**COMMISSION FOR
HISTORICAL & ARCHITECTURAL
PRESERVATION**

STAFF REPORT

REQUEST: Concept Review-- Demolish one-story rear addition on White House and construct new one-story building

ADDRESS: 100 South Linwood Avenue, Patterson Park (Baltimore City Landmark)

Image 10 – East elevation of White House, with shed-roofed board-and-batten addition.

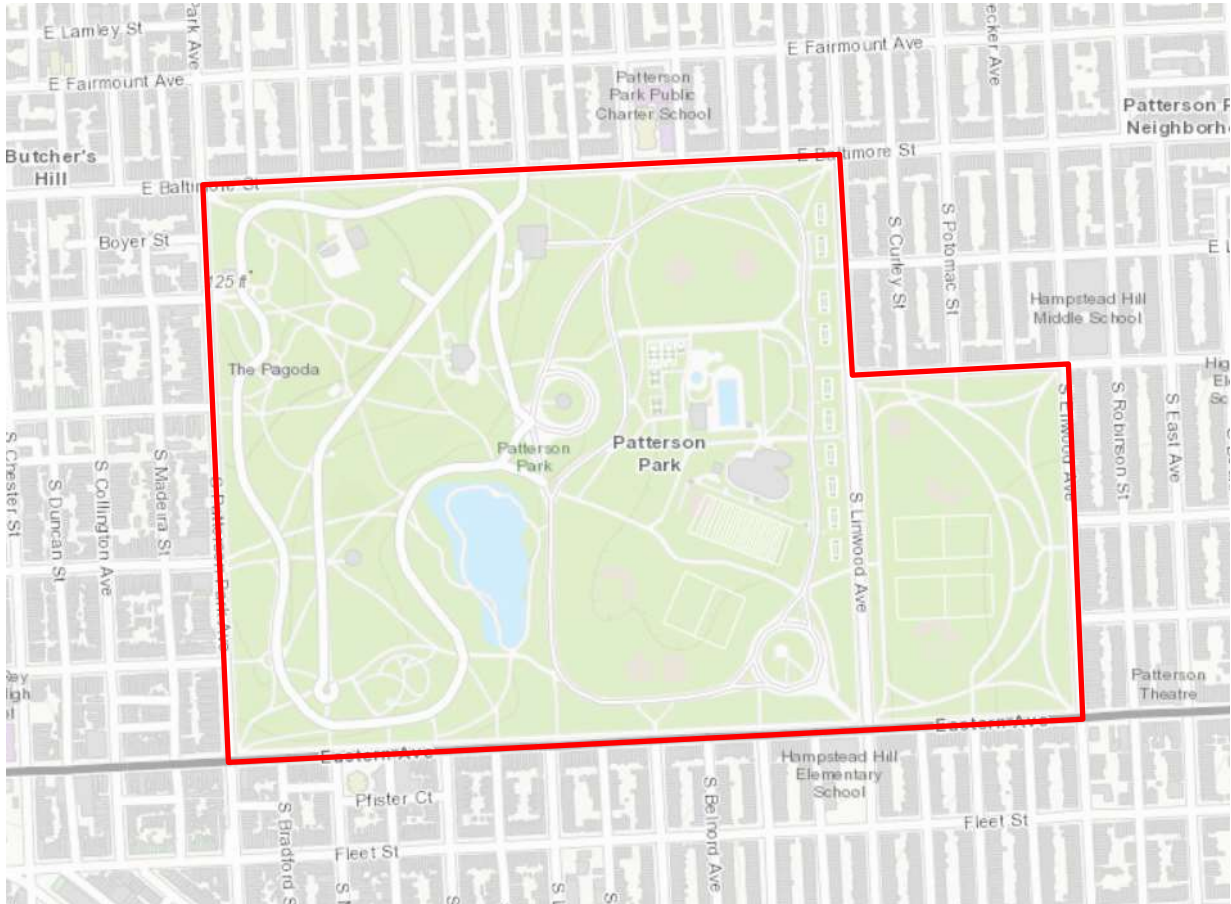
This proposal will demolish a small board and batten frame addition with a shed roof on the rear of the structure. This utilitarian addition was constructed in the 20th century and is not an architecturally significant addition to the building. Thus, staff recommends approval of demolition of this addition.

CHAP staff has determined that the one-story board-and-batten rear addition on the White House dates to the 20th century and is not an architecturally significant addition to the building. Thus, staff recommends approval of demolition of this addition.
